**TOWN OF MOUNTAIN VILLAGE
REGULAR DESIGN REVIEW BOARD MEETING AGENDA
THURSDAY AUGUST 1, 2024, 10:00 AM
MOUNTAIN VILLAGE TOWN HALL
455 MOUNTAIN VILLAGE BLVD, MOUNTAIN VILLAGE, COLORADO
TO BE HELD HYBRID THROUGH ZOOM:
<https://us06web.zoom.us/j/88262566269>
Meeting ID: 882 6256 6269**

3.	10:02	30	Perez/ Applicant	Quasi-Judicial	Consideration of a Design Review: Final Architecture Review for a new single family detached condominium at Lot 649R, TBD Boulders Way Unit 11, pursuant to CDC Section 17.4.11.

FROM: Claire Perez, Planner II

1 CONSTRUCTION MITIGATION PLAN

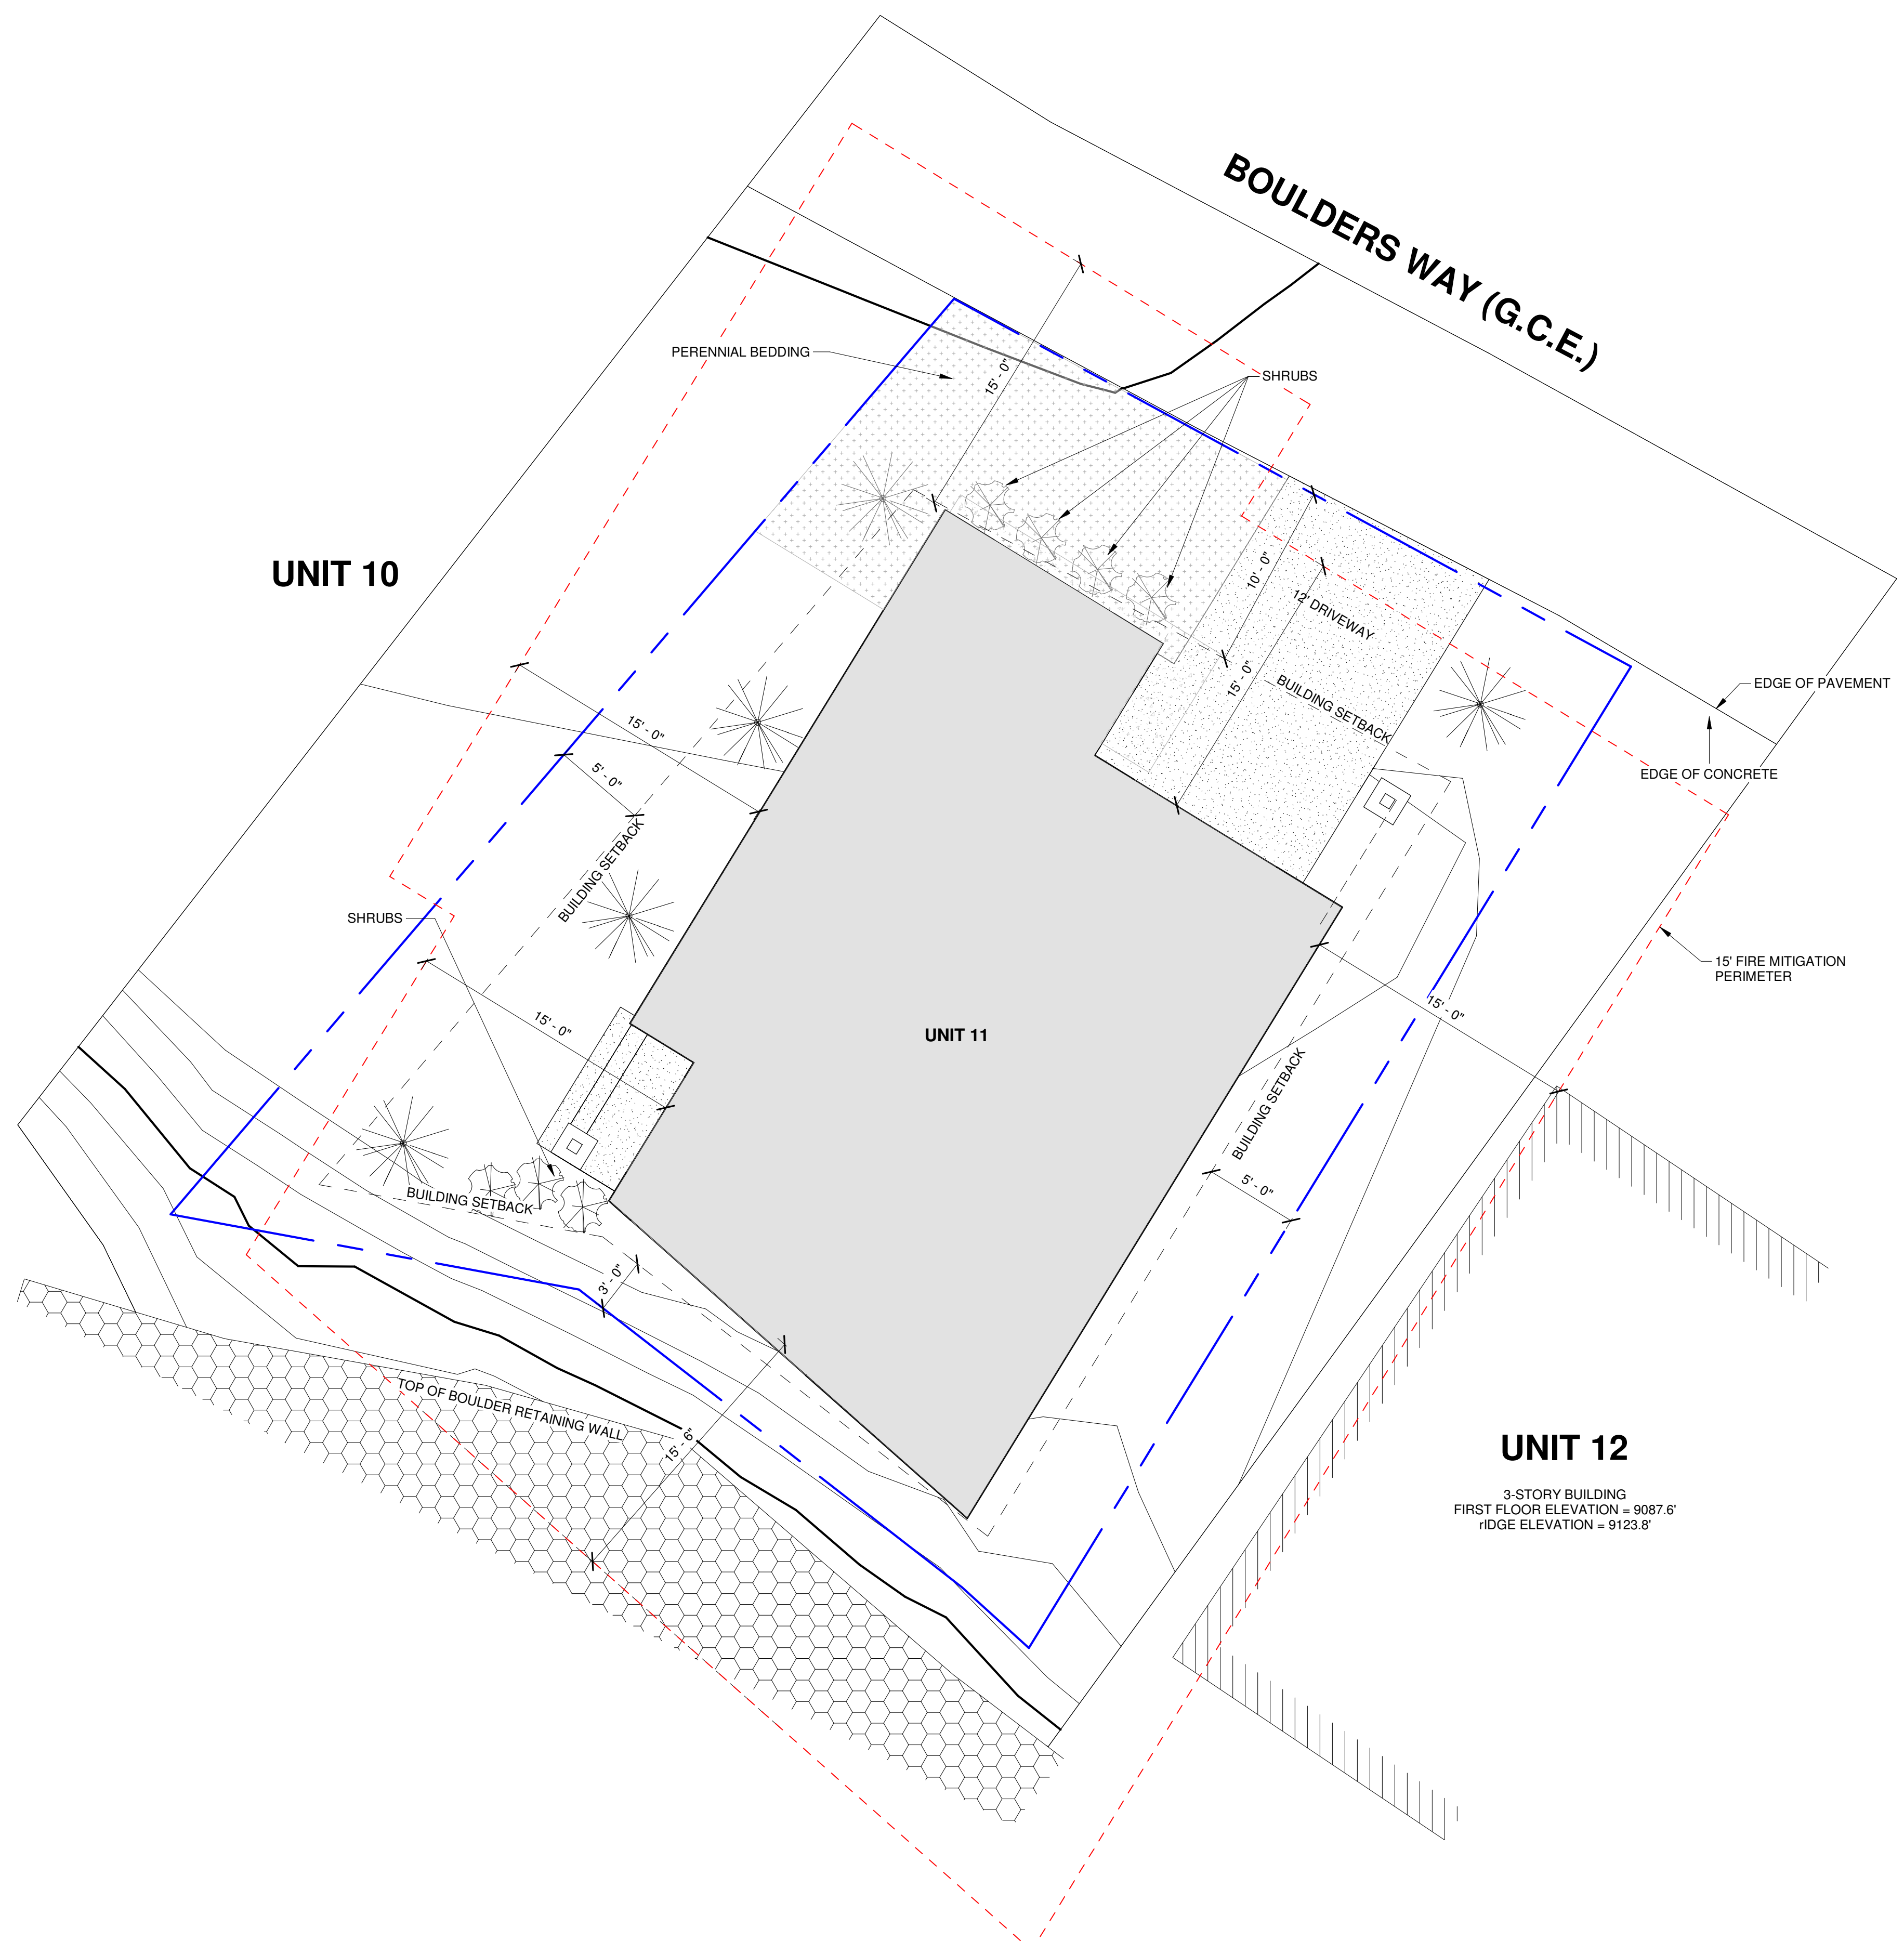
Staff: A construction mitigation plan was provided on Sheet C3. The plan does not include onsite parking. The applicant will need to coordinate off-site parking with the Town prior to building permit issuance. Workers will likely need to be shuttled from off-site during construction. The plan includes a dumpster, porta-toilet, and material laydown area. The dumpster must be bear proof. The plan should be revised to include storm water management devices such as silt fencing and wattles. As a condition of approval, the applicant shall revise the Construction Mitigation Plan to include off-site parking as well as stormwater management devices that meet Town standards.

- 1) Prior to building permit, the applicant shall revise the landscape and fire mitigation plan to remove the bristle cone pines from zone 1.
- 2) Prior to building permit, the applicant shall revise the construction mitigation plan to include stormwater management devices.

Utility Plan

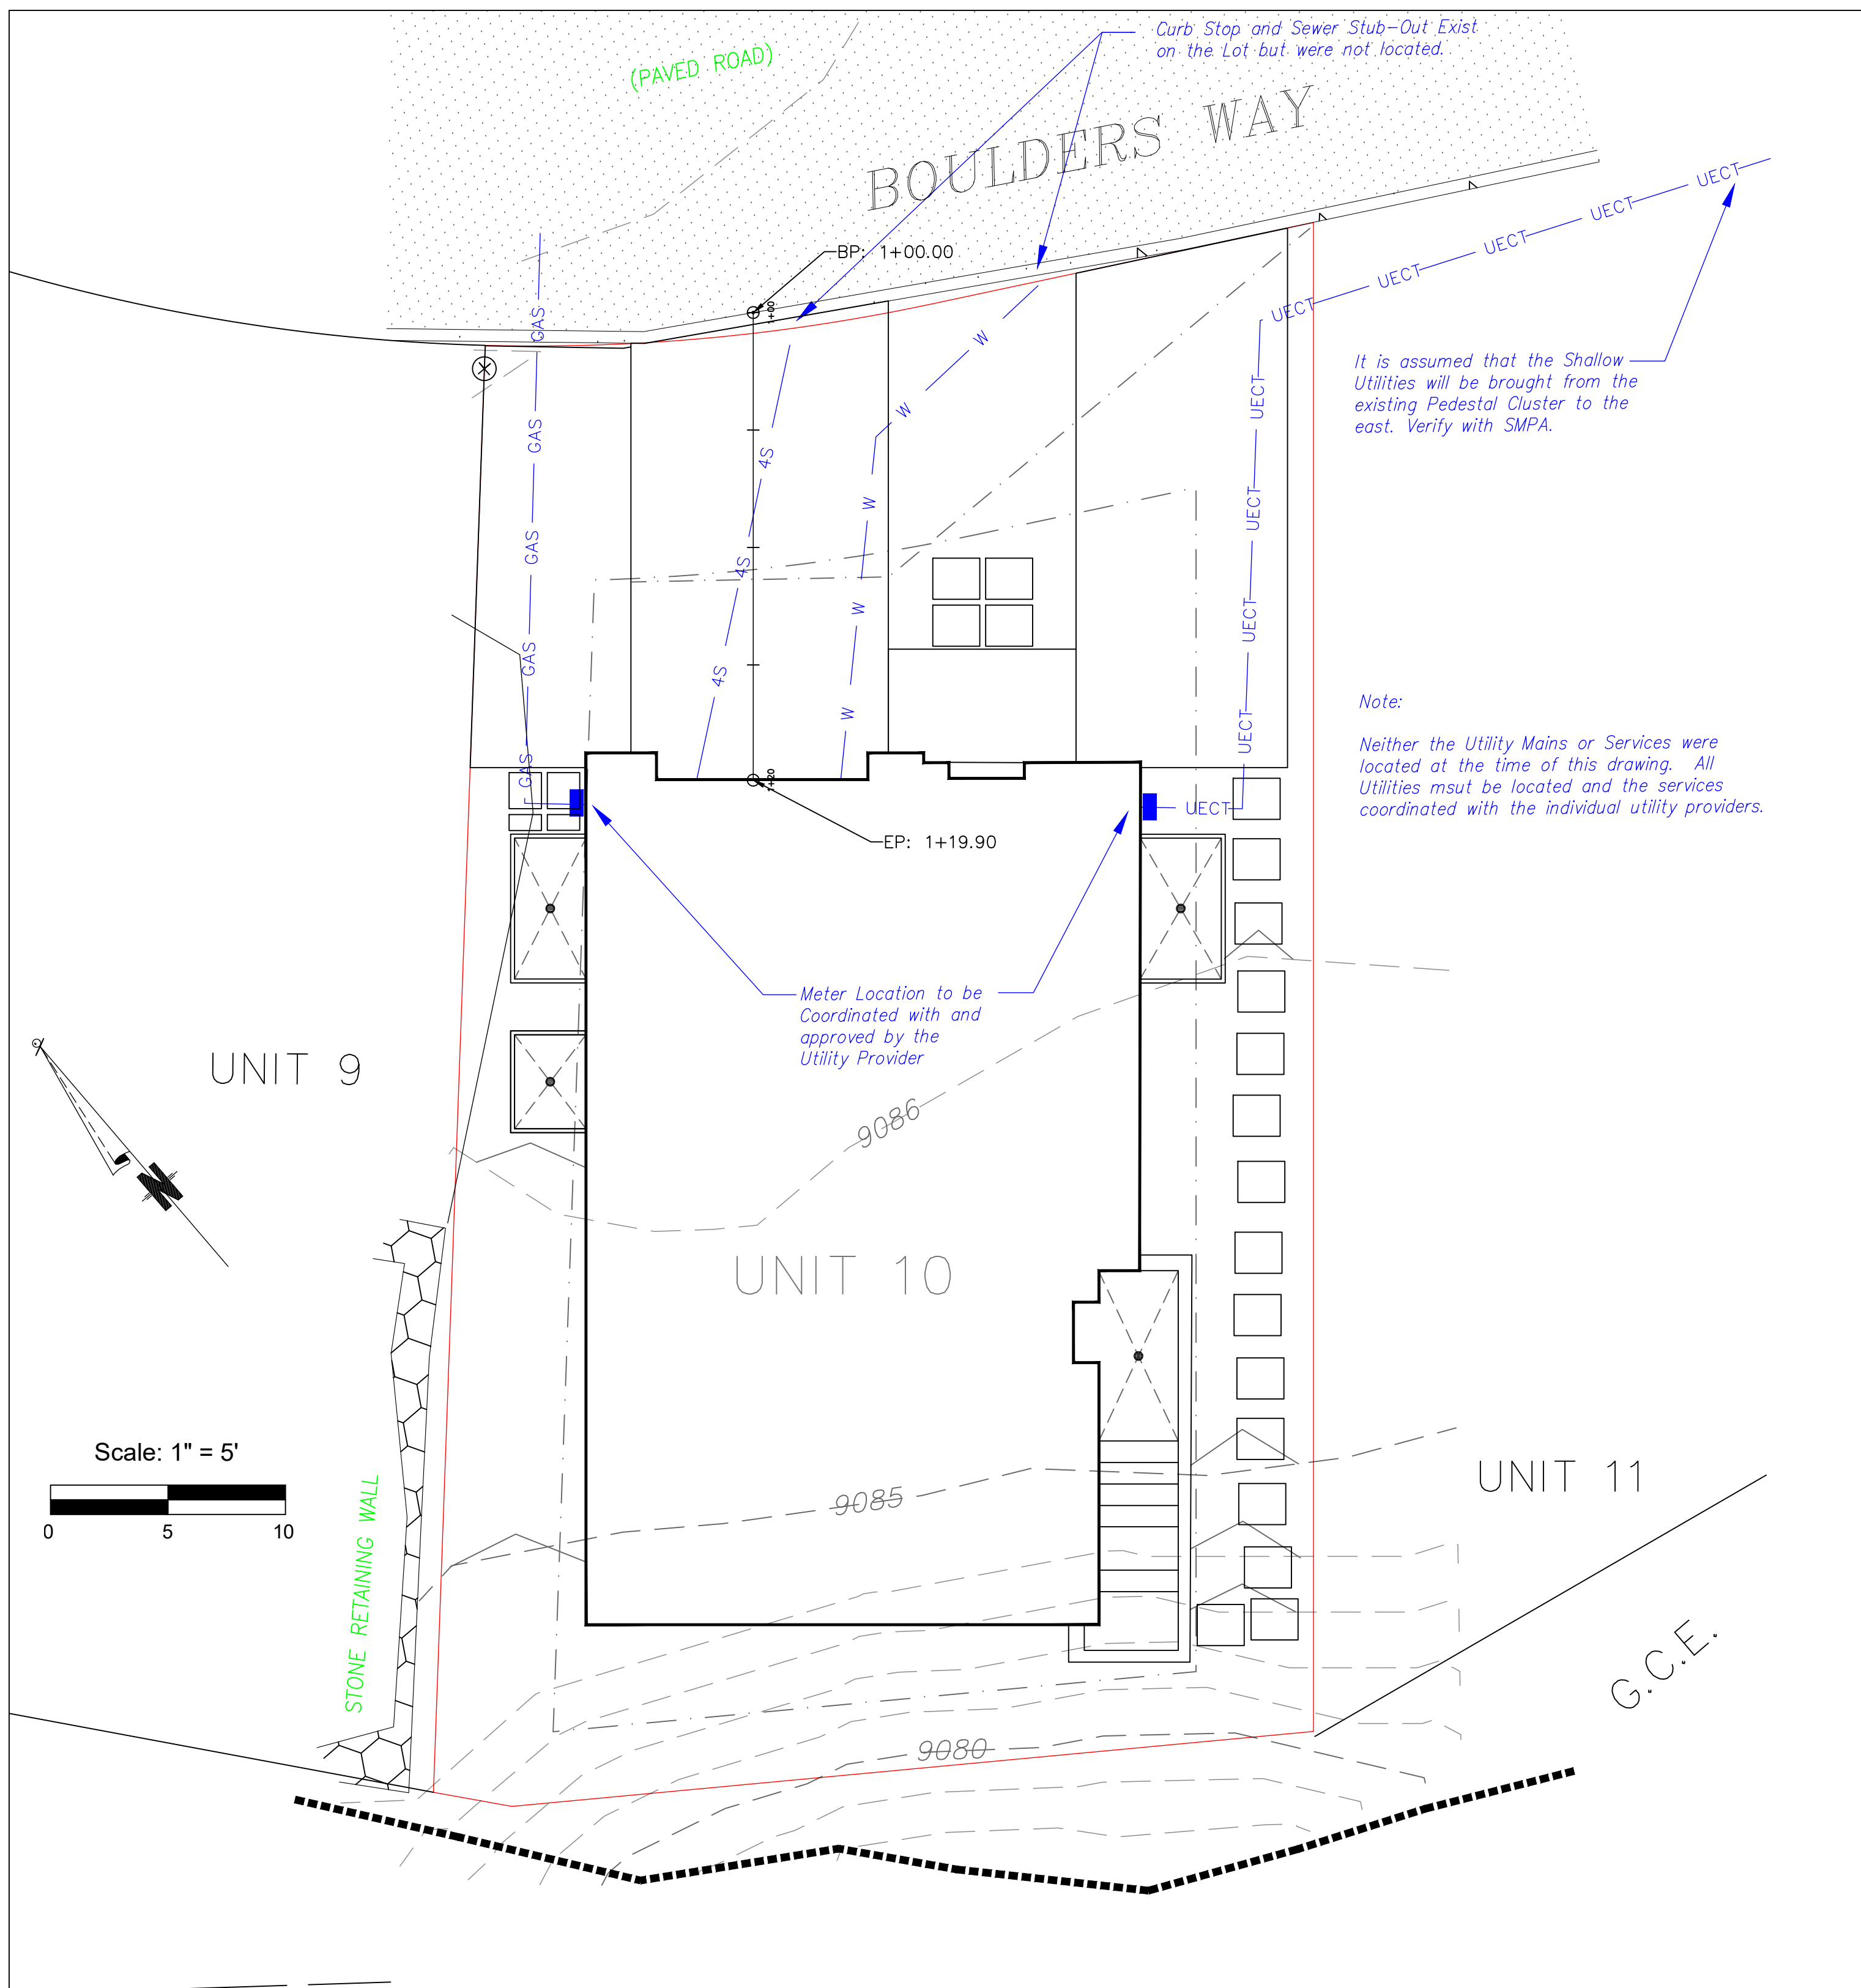
Staff: The applicant provided a utility plan on Sheet C2. The plan shows the sewer and gas lines crossing the front setback to connect in Boulders Way. The electricity lines will cross the side setback to connect to an existing Pedestal to the east. Staff sees no issues with this plan. The applicant will need to field verify the proposed locations.
